SIDE PANEL

ROOF PANEL

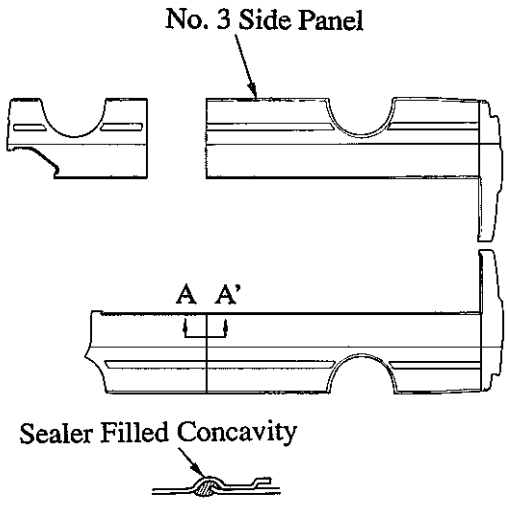
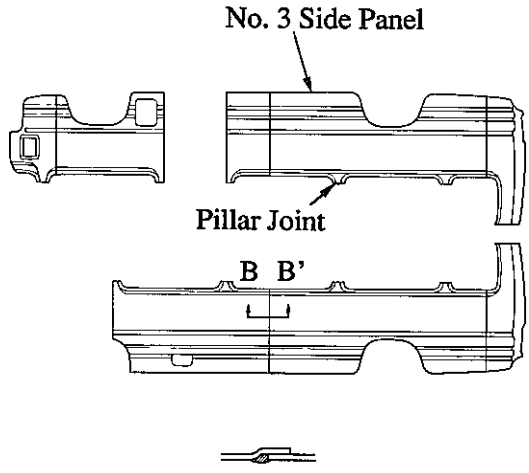
To provide high rigidity, the pillar joints of the side panel have been made flat and the No. 3 side panel on the passenger side changed to a single panel. At each panel joint a concavity has been created for sealer application to provide outstanding rust resistance.

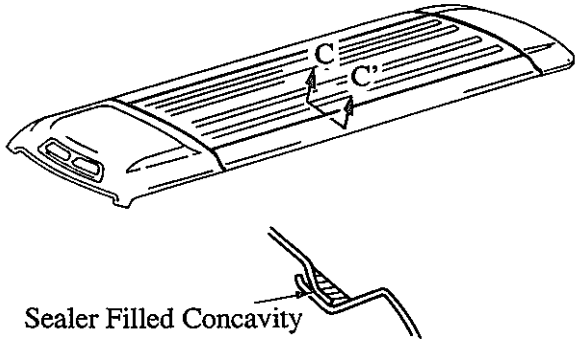
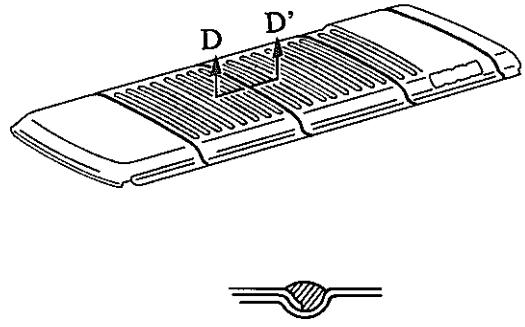
The division of the roof panel sections has been changed to provide greater rigidity. And a concavity for sealer application has been created at each panel joint to provide outstanding rust-resistance.
